2017 Corvette: GM TechLink: 3rd Gear Condition on Manual Transmission

3rd Gear Condition on Manual Transmission

GM TechLink

November 23, 2016

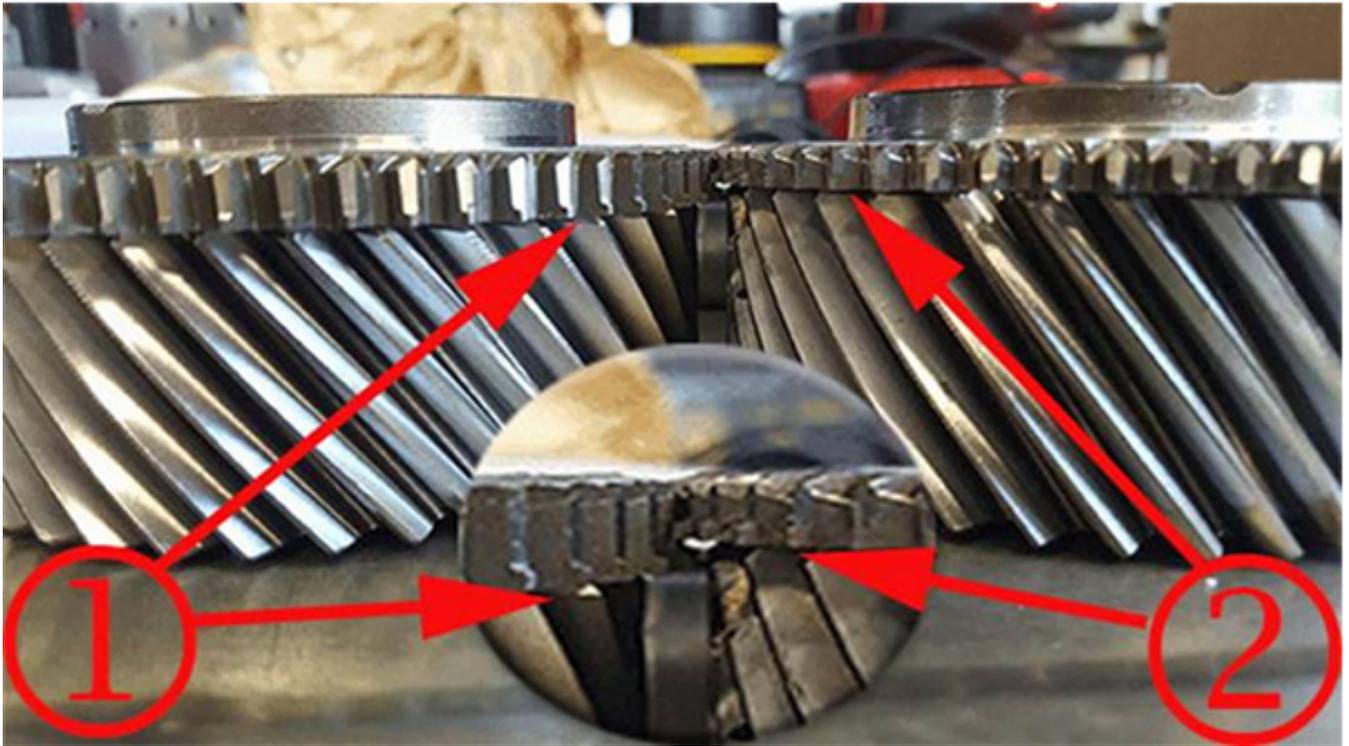
If the transmission does not hop out of 3rd gear, shift back to 2nd gear and repeat the shifting and accelerating procedure 10 times. If the transmission does not hop out of 3rd gear, the transmission has the correctly machined gear. (Fig. 14, #1) If the hop out of 3rd gear is verified, there is a mis-machined gear (Fig. 14, #2) and the 3rd speed gear, synchronizer and shift collar should be replaced.
